<b>Title</b>	ISH9 and Deadline 7 Noise Responses		
<b>Project</b>	Gatwick Airport DCO		
<b>Reference</b>	28AD.NT.8.0	<b>Author(s)</b>	BHo
<b>Date</b>	6 August 2024	<b>Reviewer</b>	VC

1. This note sets out Suono's written response to the noise-related aspects of Issue Specific Hearing 9 and the Applicant's Deadline 7 documentation.
2. Our response to Action Points 10 and 11 are both included within this note, alongside the requested response to GEN.2.11.

**Image 1 – Figure 14.9.4 cropped**

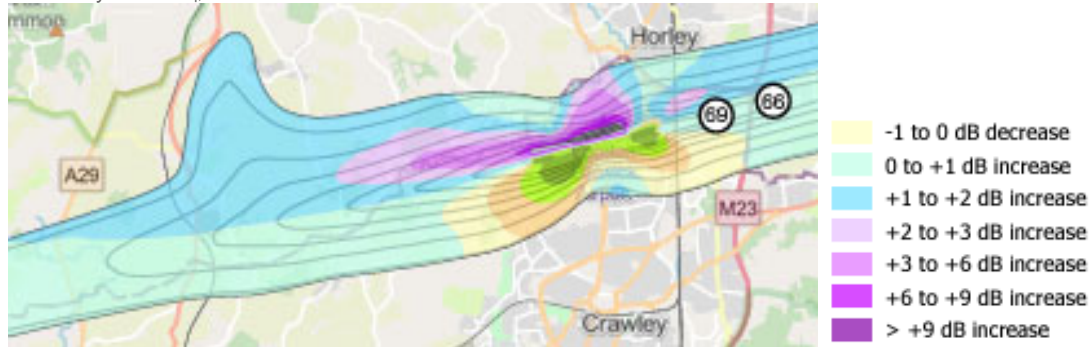
33. Figures 14.9.4 and 14.9.10 of APP-064 show the noise differences between 'With Project' and 'Baseline' in 2032 for the daytime and night-time, respectively. No corresponding figures are provided for 2028, despite this being the worst-case noise year.

34. These figures show that local communities under the new runway flightpaths are expected to experience material increases in noise in both the day and night-time and they are replicated on the page below.

35. It is extremely difficult to identify where residences might be within these noise contours, as the Applicant has not provided any detailed mapping, despite the requests since REP1-113. However, it is clear that there will be noise-sensitive buildings in areas that would experience material increases in noise.

36. These are the communities that arguably are the most affected by the introduction of a new runway. The Applicant does not propose to insulate these buildings, residential or otherwise, until after the new runway is in operation, potentially leading to several years of material noise increases.

37. The Noise Insulation Scheme in these areas therefore only constitutes compensation and not mitigation, as the effect would already have occurred.
